SB-GA8-2005-23

Service Bulletin

Forward Cargo Door Slide

All GA8 serial numbers.

Figure 3: Worn slider indicating where to measure.

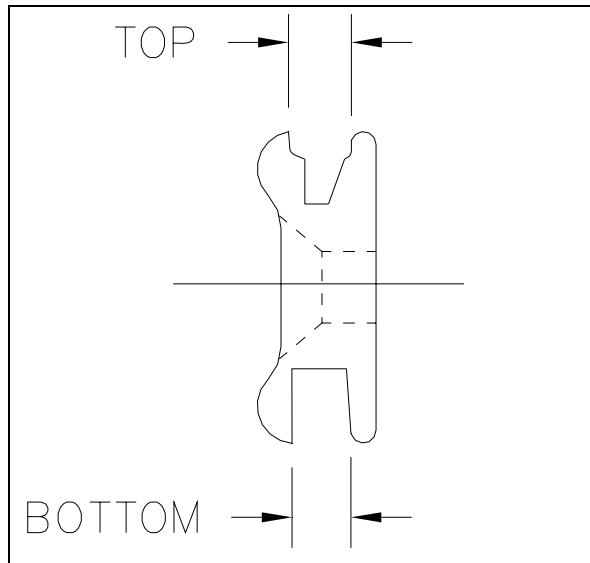
3. Figure 3 below shows how a worn part normally looks and where to measure the groove width. The TOP and BOTTOM profile differs on a worn part and as such both the top and bottom slide grooves are to be measured with a calliper.

4. Measure the groove width and if the groove is wider than 0.145" at any point along the slider or if the part is cracked or excessively worn a new slider, Item 1, must be fitted.
5. Irrespective of Item 1, Items 2 to 7 **MUST** be fitted as shown in Figure 4 and listed in Table 2 below.

Figure 5: Checking with the Forward Slide Gauge (all four corners require checking)

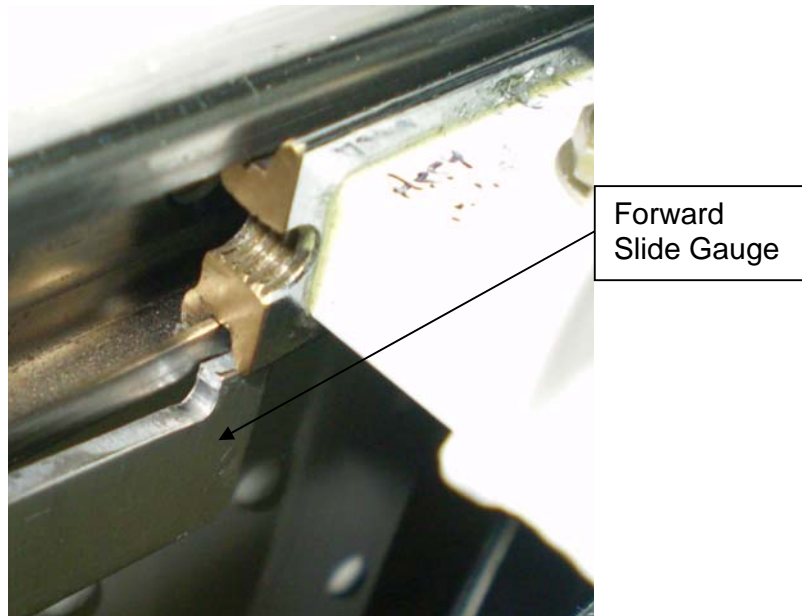
1. Open the door handle so that the door swings out to gain access to the slider (see ACTION 1, Para 1)
2. Try to insert the Forward Slide Gauge (Item 8, Table 1) between the slider and the track as shown in Figure 5 and Figure 6 below. Standard Feeler gauges made up to 0.098" (0.023"+0.024"+0.025"+0.026") may also be used.

3. If it is possible to fit the Forward Slide Gauge or feeler gauge between the track and slider (as shown in Figure 6 above) at any of the four corners carry out ACTION 1 Para 2 to 4.
